Determination 2013/032

The refusal to grant building consent for a prefabricated building

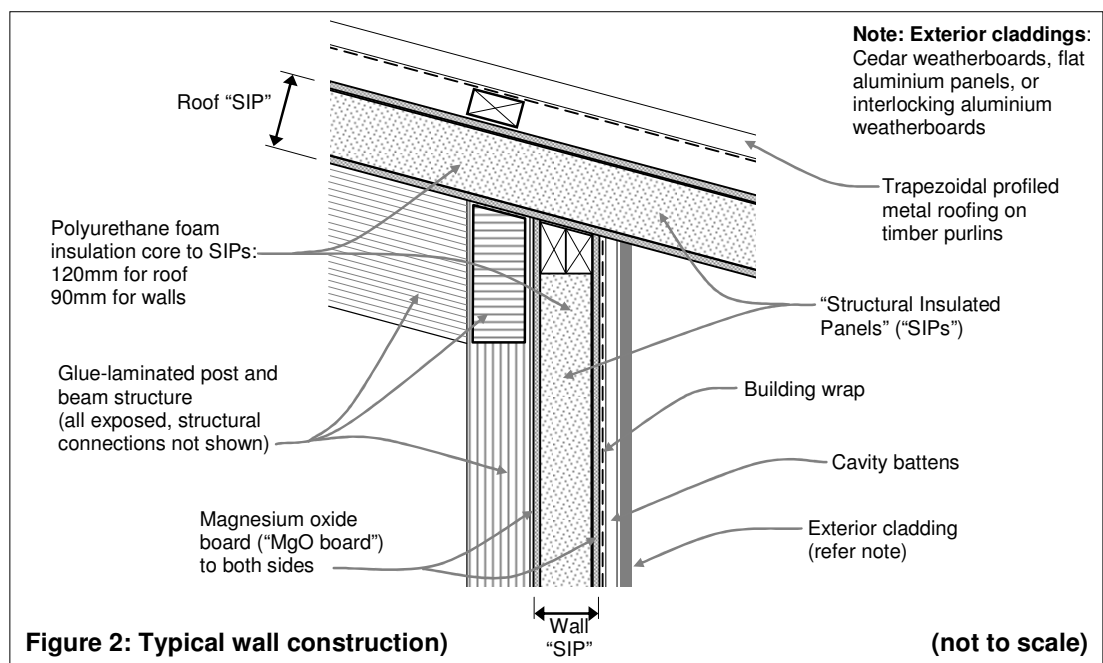
- 2.3.2 The exposed glue-laminated posts and beam structure of the house consists of 112mm x 112mm posts spaced at about 3.6m, which support 240mm x 90mm roof beams, with intermediate 190mm x 90mm rafters between. Bracing is provided by 'structural insulation panels' ("SIPs") as sketched in Figure 2.

- 7.2.2 The authority has concerns about the durability of the wall and roof SIPs, taking into account their function as bracing elements in the building. The engineer has provided a comprehensive set of drawings, together with a producer statement for the design and an inspection schedule which includes fixings and connections of the panels during installation and prior to closing in the building.

- 7.2.3 In regard to the likely durability of the SIP's, I note the following:
- The engineer will inspect SIP installation, which is expected to be included in a producer statement for construction review on completion as compliant with Clause B1. After installation, panel joints are sealed to provide a moisture and air barrier in the form of the moisture-resistant MgO board.

- 7.2.4 Taking the above into account, I have reasonable grounds to conclude that the house structure will comply with Clause B2 Durability insofar as it applies to Clause B1.

Figure 3: The SIP joints (not to scale)

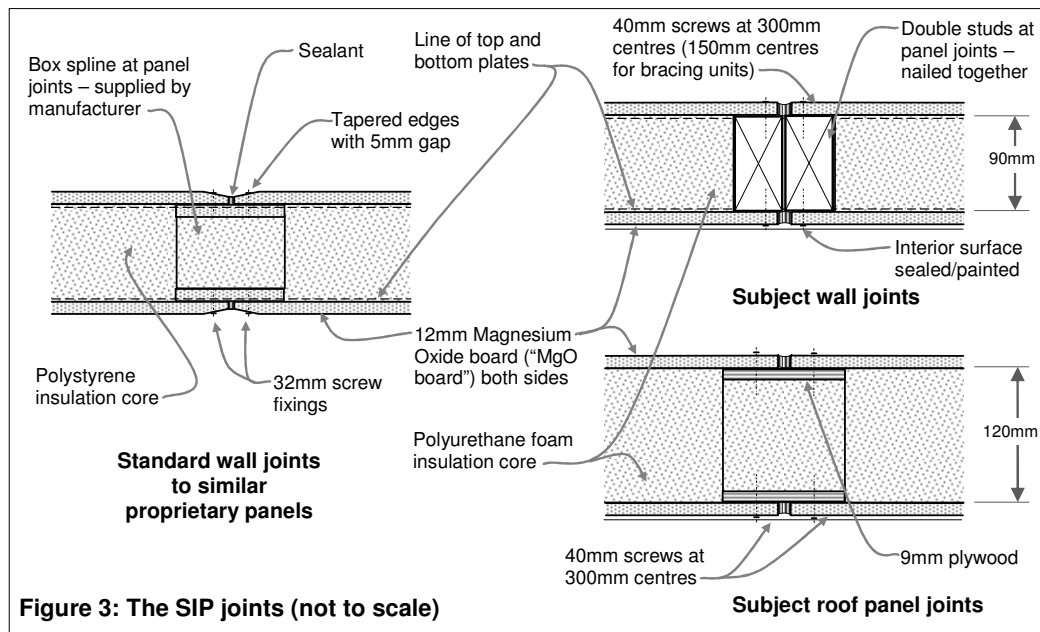
2.4.3 Similar proprietary systems incorporate a ‘box spline’ provided by the manufacturer at panel joints. In the case of this proposed building, the panels provide bracing to the post and beam structure and joints and junctions are therefore specifically designed and detailed by the engineer. A ‘standard’ proprietary joint is compared to typical panel joints for this building in Figure 3:

2.4.4 The SIPs are faced with MgO board as shown in Figures 2 and 3. The MgO board is sealed at vertical joints; providing a rigid air barrier beneath the building wrap, while interior faces act as ceiling and wall linings. MgO board is further described in paragraph 2.5.

- cavity batten fixings are buried within handwritten calculations
 - the lack of top plates to details 1, 2 and 3 on WO5
 - the lack of a specific detail for the aluminium panel joint (copy of a detail for a similar product is not sufficient)
